Access Compliance Report Public Rights-of-Way (Curb Ramps)

Main Street: DORRANCE_DR Cross Street: O_NEILL_DR Location: S

ADA ID: RPRK211118121513 Ramp Type: Type 6 - Directional 1 Initial Pass/Fail: Fail Overall Compliance: No Severity Score: 30

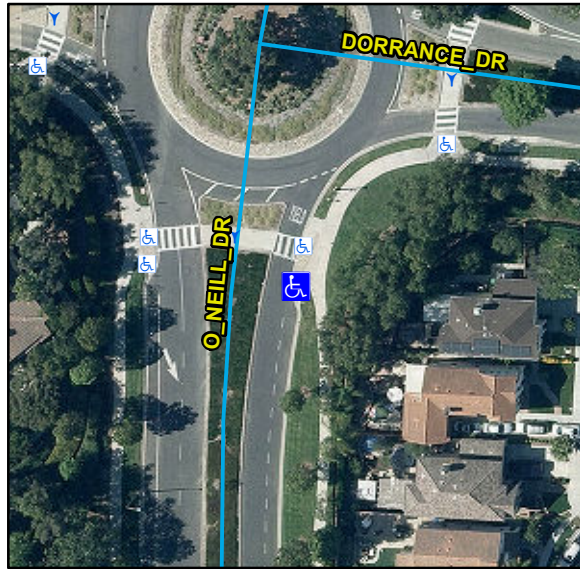
Compliance	Description	Data	Compliance	Description	Data
N/A	Ramp Length (in)	100	N/A	Flare Type LT	
Yes	Ramp Width (in)	54			N/A
No	Ramp Run Slope (%)	16.8	N/A	Flare Slope LT (%)	N/A
Yes	Ramp Cross Slope (%)	0.7	N/A	Flare Traversable LT	N/A
N/A	Grade Break	N/A	N/A	Flare Type RT	
N/A	Grade Break Slope (%)	N/A			N/A
N/A	Grade Break Cross Slope (%)	N/A	N/A	Flare Slope RT (%)	N/A
	Addl Para Ramp Left?	No	N/A	Flare Traversable RT	N/A
	Addl Para Ramp Right?	No	N/A	DWS Provided	N/A
N/A	Landing Present	N/A	N/A	DWS Contrast	N/A
N/A	Landing Length (in)	N/A	N/A	DWS Length (in)	N/A
N/A	Landing Width (in)	N/A	N/A	DWS Full Width	N/A
N/A	Landing Run Slope (%)	N/A		DWS Offset Type	N/A
N/A	Landing Cross Slope (%)	N/A	N/A	DWS Left Offset (in)	N/A
N/A	Landing Movement Obstructed?	N/A	N/A	DWS Right Offset (in)	N/A
	Landing Movement Type	N/A			
N/A	Landing Shared	N/A			
N/A	Marked Crosswalk 1	No	N/A	Clear Space	N/A
	Crossing 1 Direction	SW	N/A	Clear Space To Crosswalk (in)	N/A

Marked Crosswalk 1 Width (in)	N/A			
N/A	Ramp Inside Crosswalk 1	N/A			
	Crossing 1 Slope (%)	0.9			
	Crossing 1 Cross Slope (%)	5.5			
N/A	Gutter Ponding	N/A	N/A	Curb Slope	7
Yes	Gutter Lip Height (in)	0		Road Run Slope (%)	N/A
N/A	Gutter Run Slope (%)	N/A		Road Cross Slope (%)	N/A
N/A	Gutter Cross Slope (%)	N/A		Parallel Ramp Side	N/A
Yes	Overall Surface Condition	Acceptable	No	Perp Joint Present	No
	Cross Gutter Present?	No		Spandrel Present?	No
	Replace Cross Gutter?	N/A		Replace Spandrel?	N/A

Possible Solutions:

Remove & Replace Entire Ramp.
